CONSTRUCTION DOCUMENTS  
GRANDVIEW RESERVE FILING NO. 1  
4 SITE INVESTMENTS, LLC (D.R. HORTON)  
SF-22-XXX  
EASTONVILLE RD & REX RD  
EL PASO COUNTY, FALCON, CO 80831

OVERALL SHEET

**C1.0**  
Sheet 5 of 29

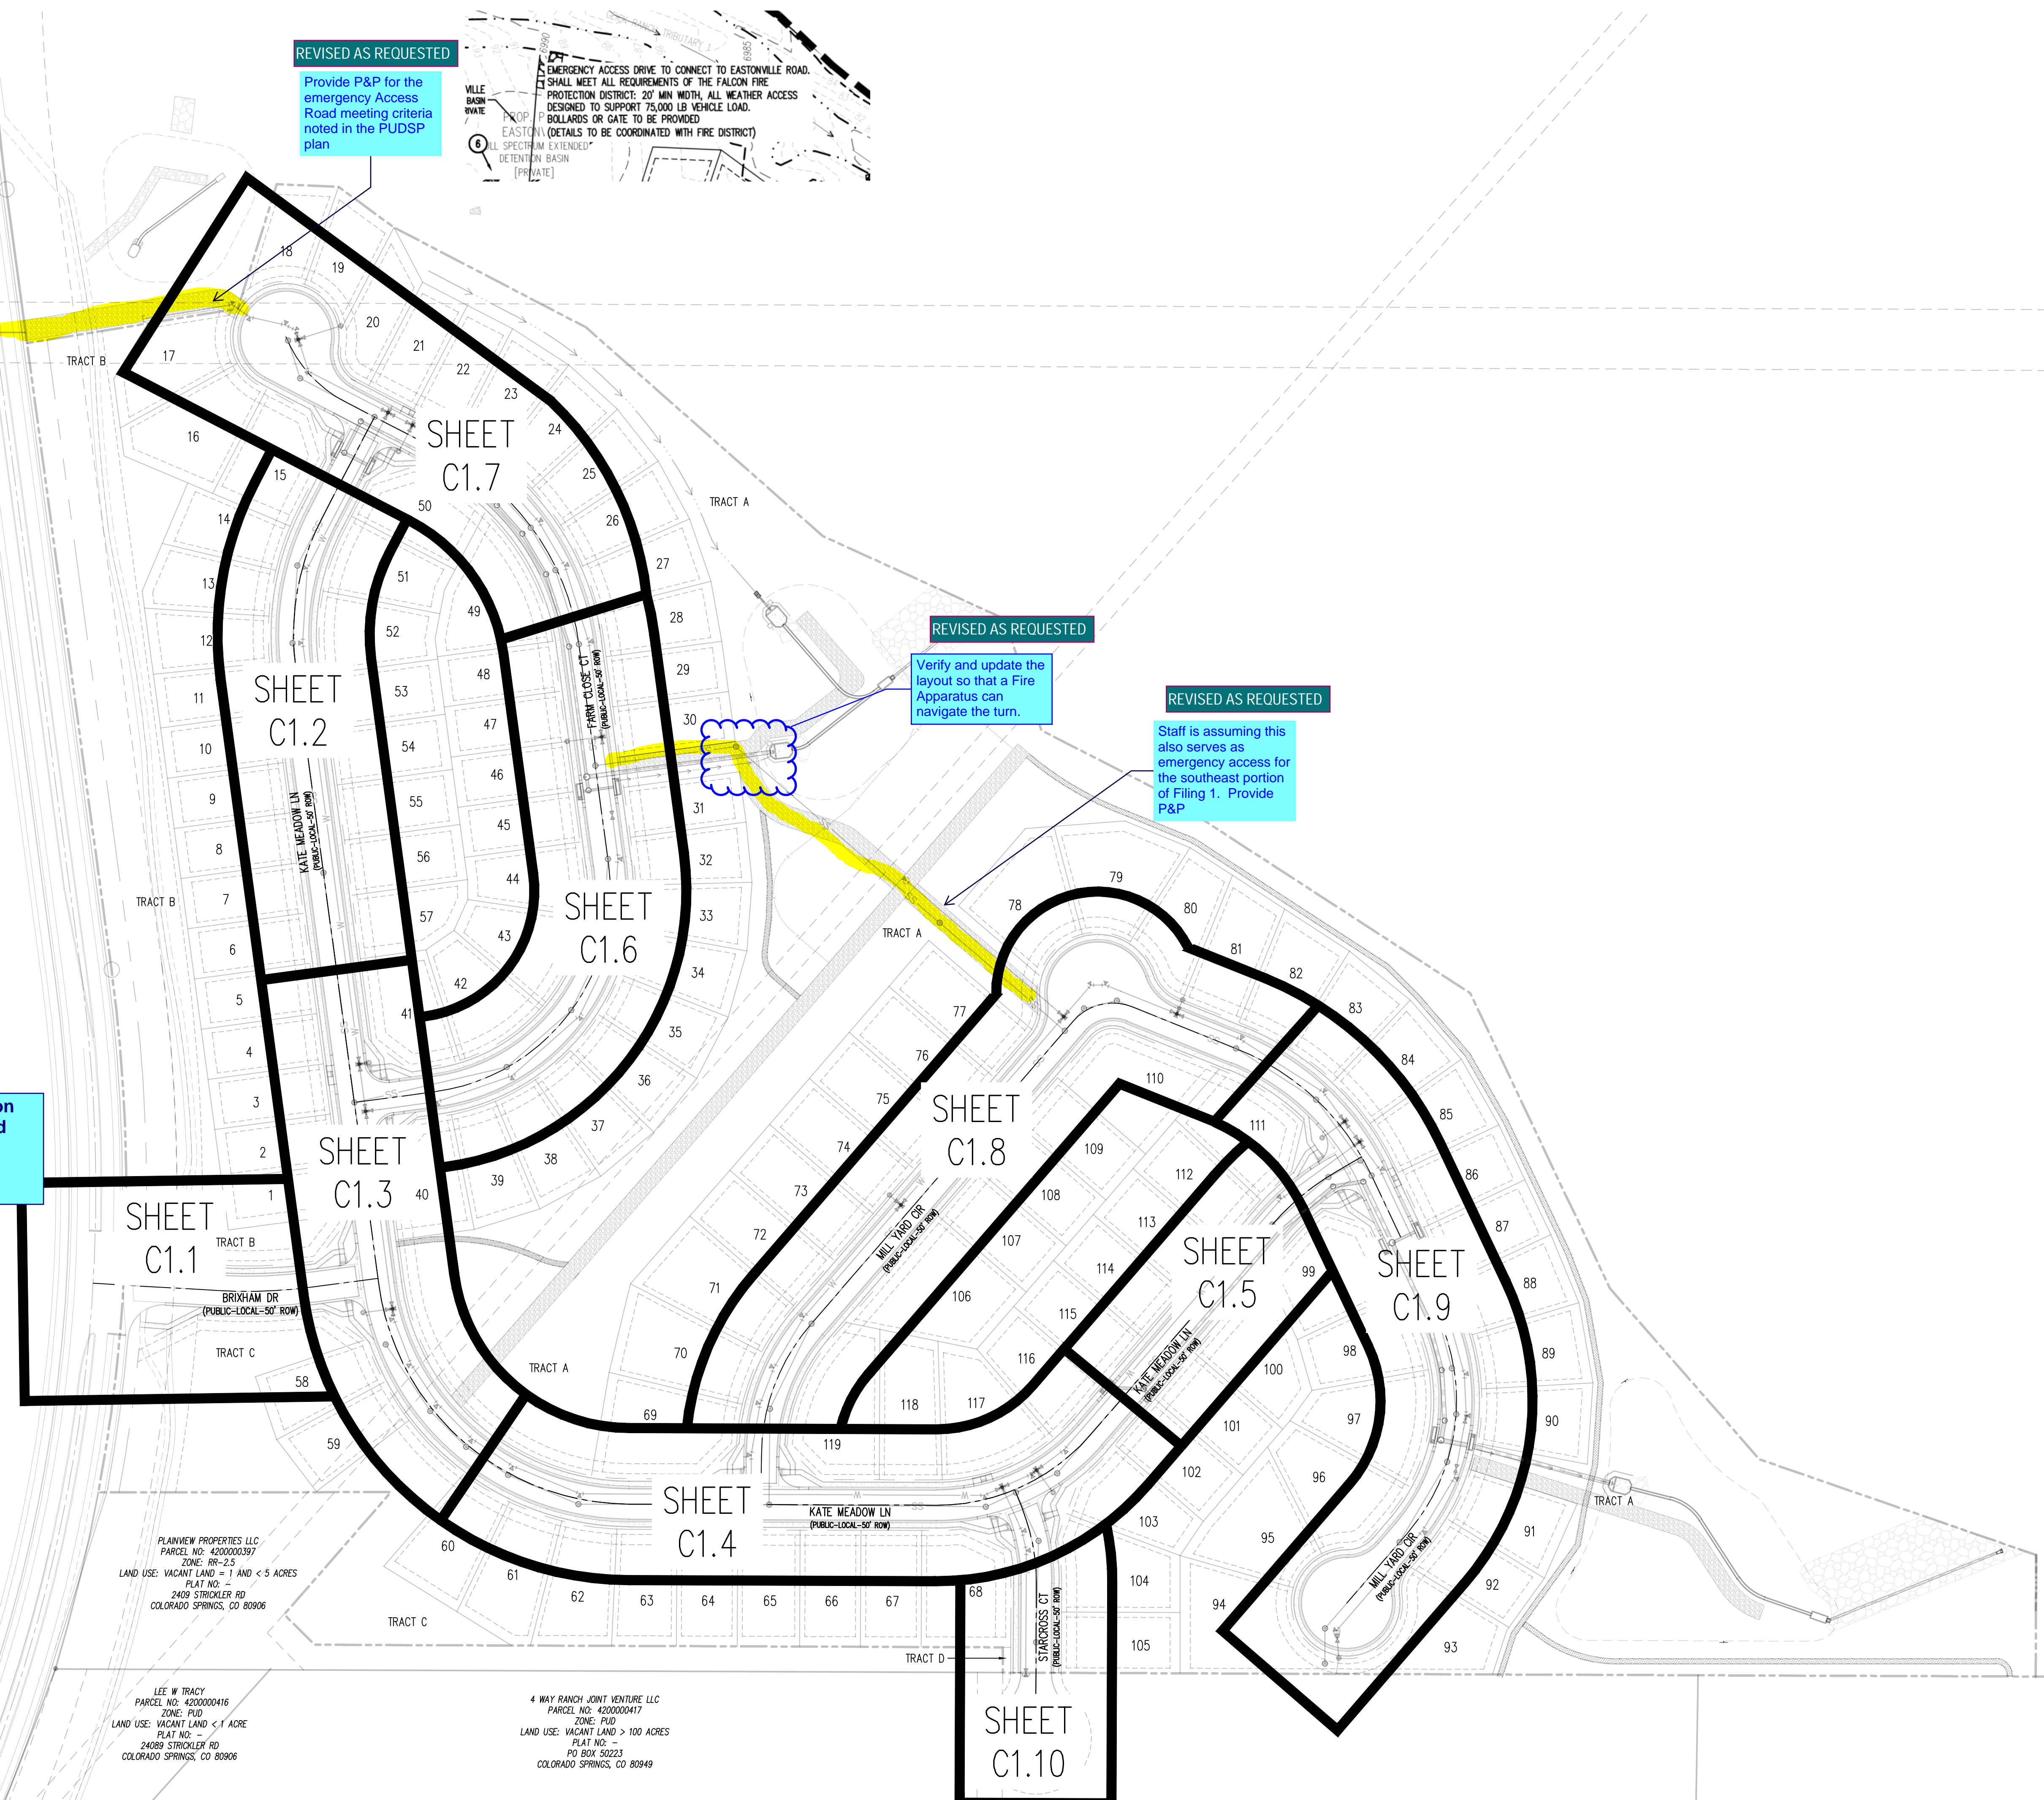
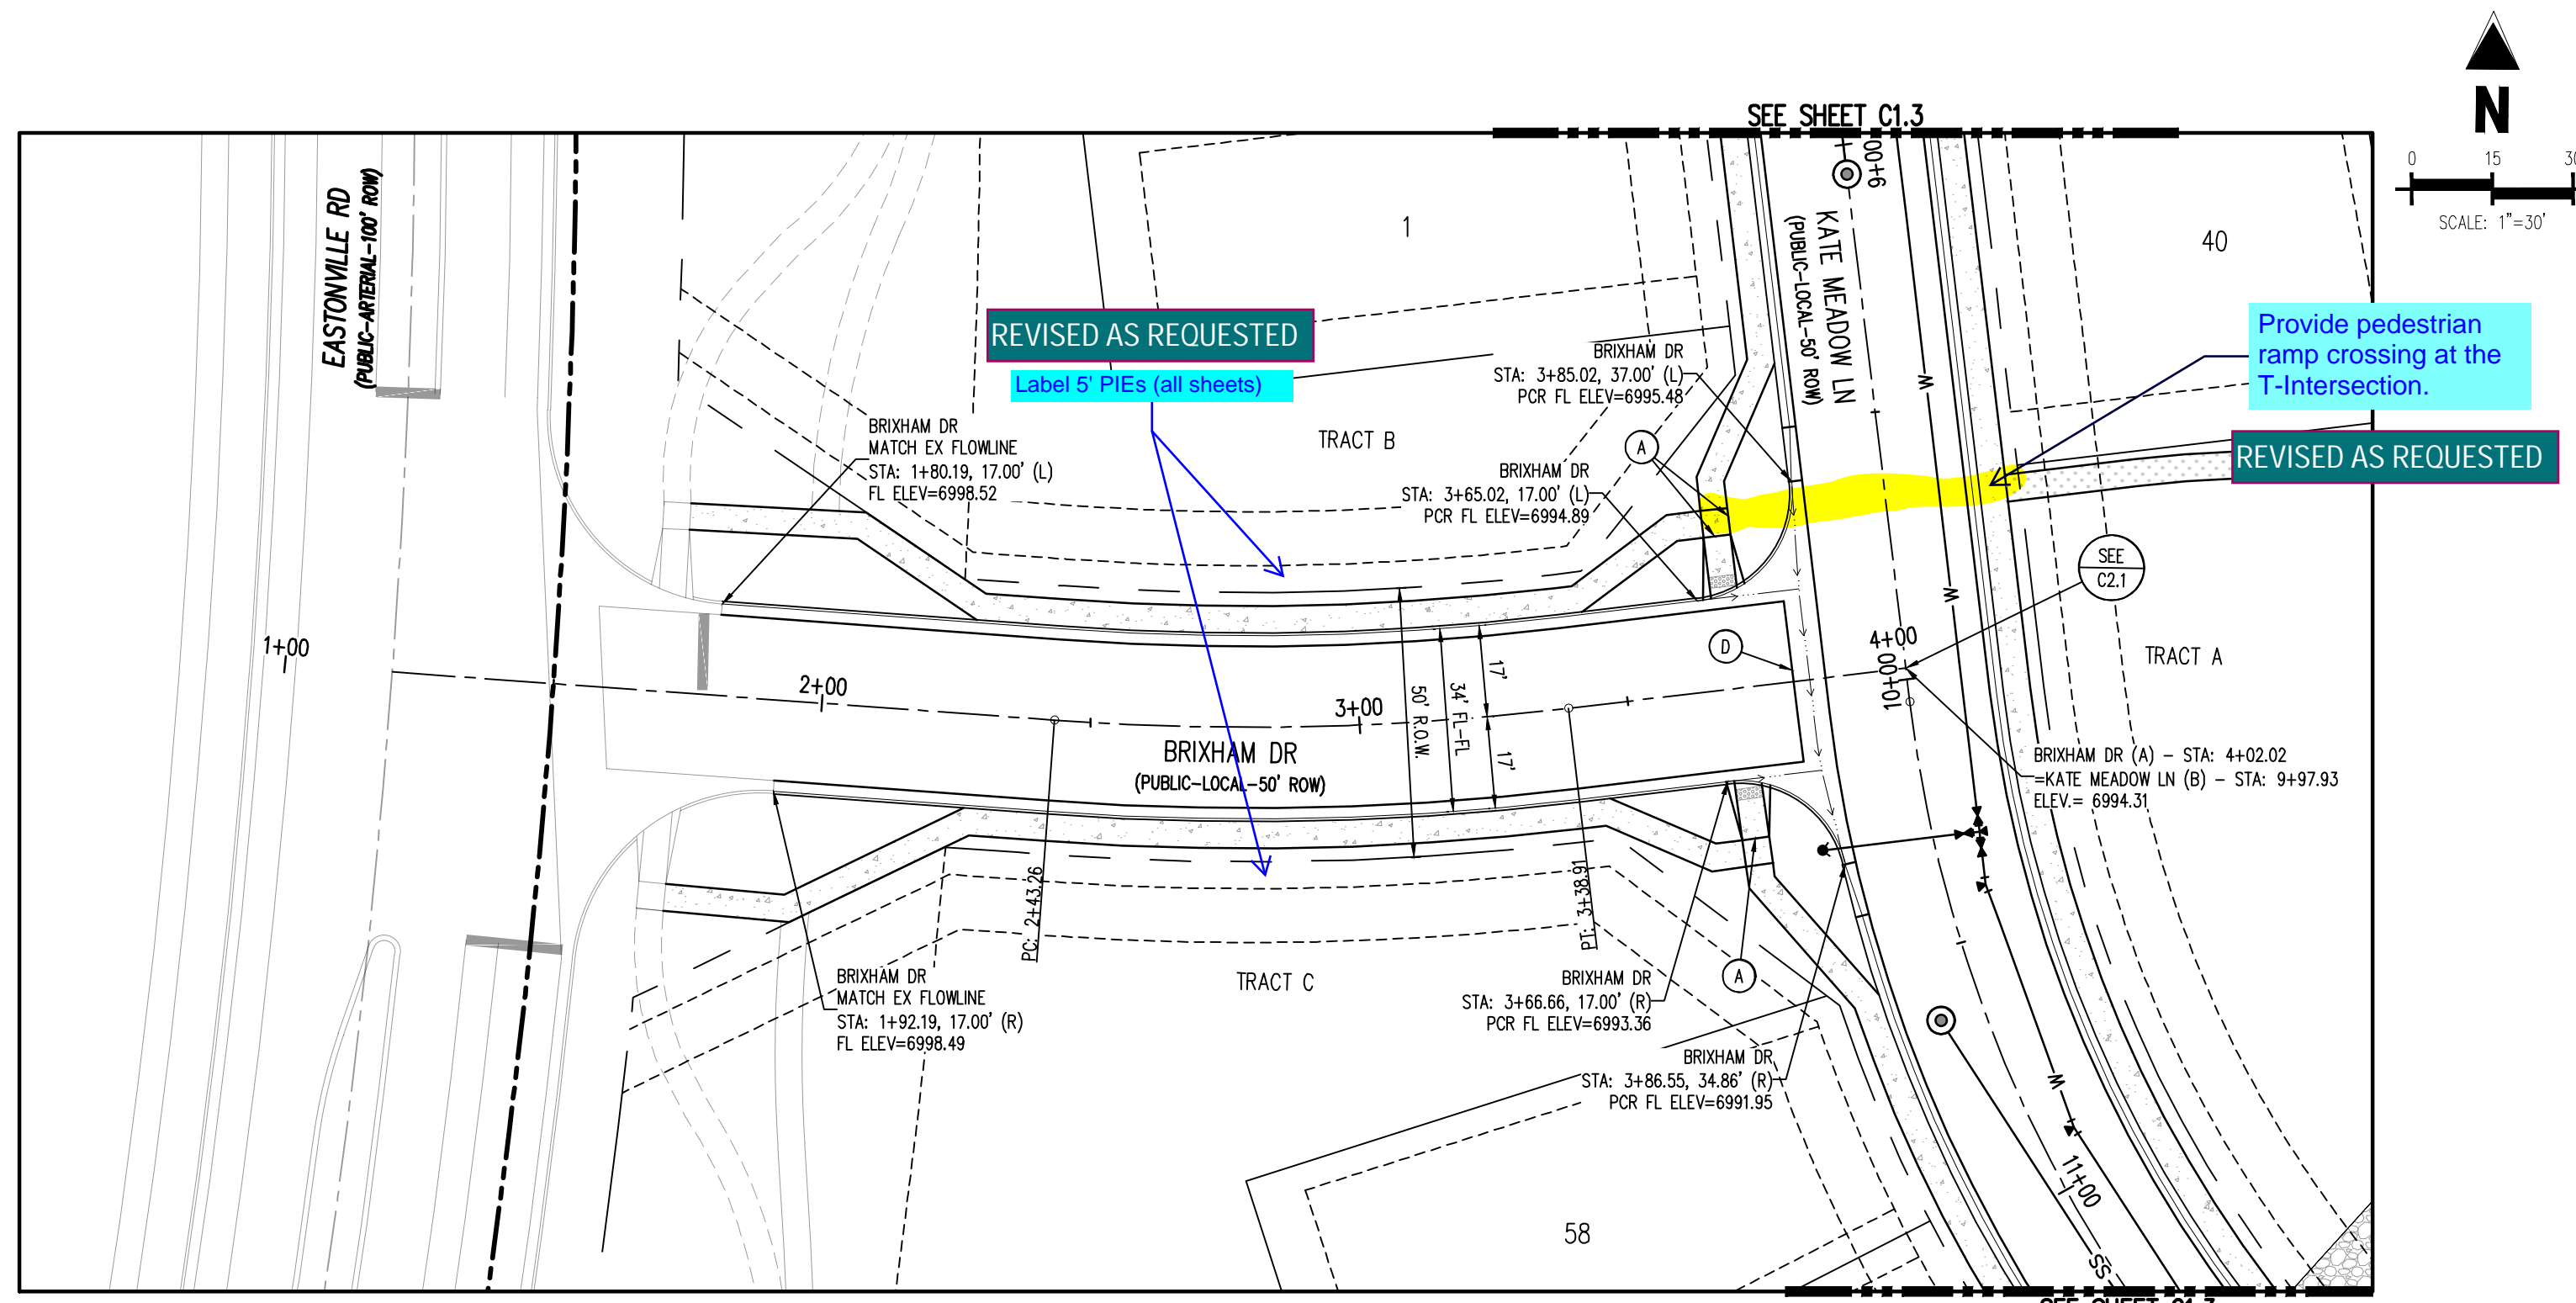
Provide P&P for the emergency Access Road meeting criteria noted in the PUDSP plan

Verify and update the layout so that a Fire Apparatus can navigate the turn.

Staff is assuming this also serves as emergency access for the southeast portion of Filing 1. Provide P&P

Provide street construction plans for Eastonville Road and update the Financial Assurance Estimate to include the quantities.

REVISED AS REQUESTED

REVISED AS REQUESTED

REVISED AS REQUESTED

ROADWAY P&P

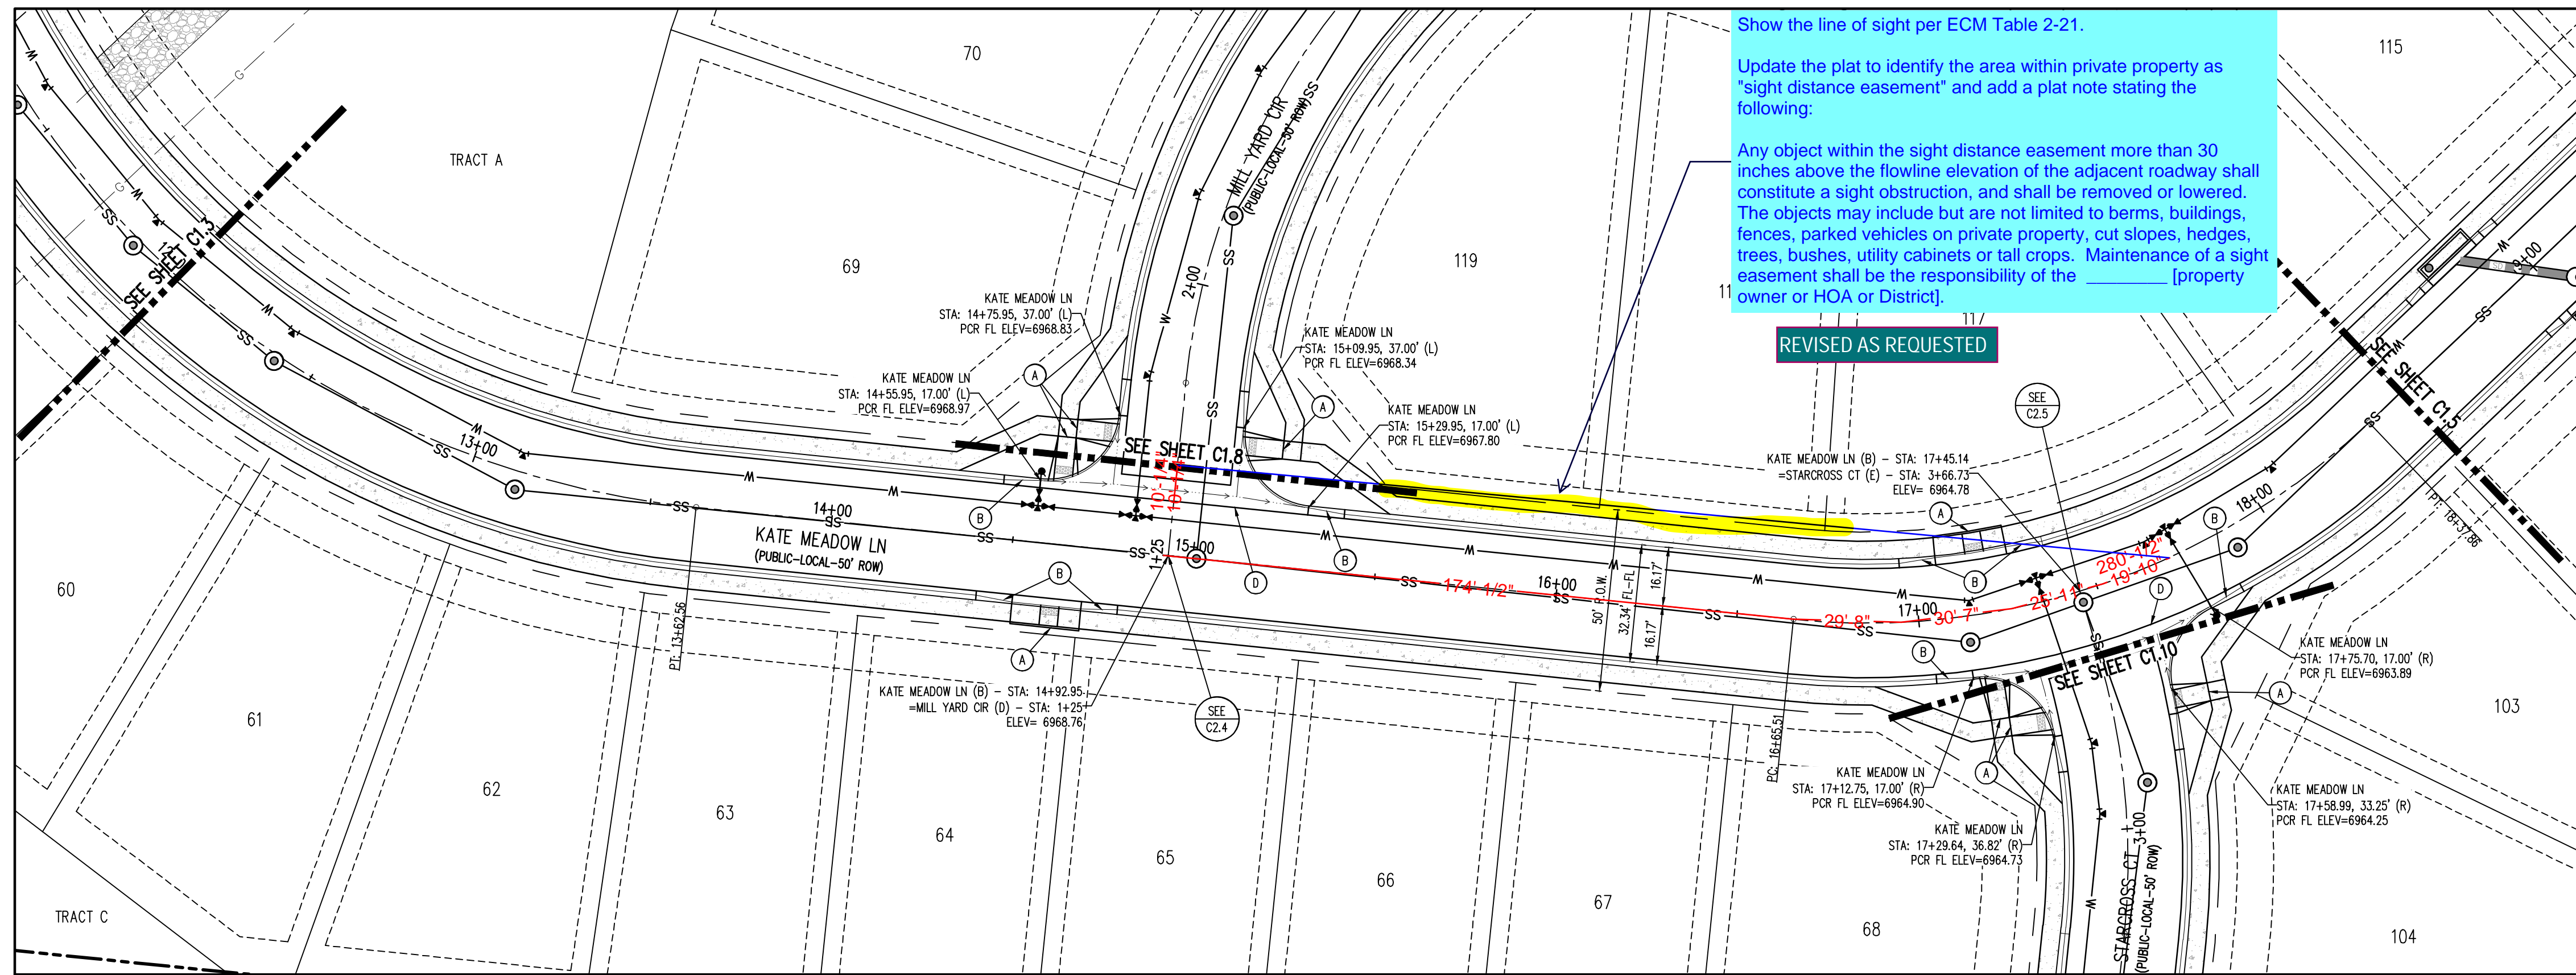
Show the line of sight per ECM Table 2-21.
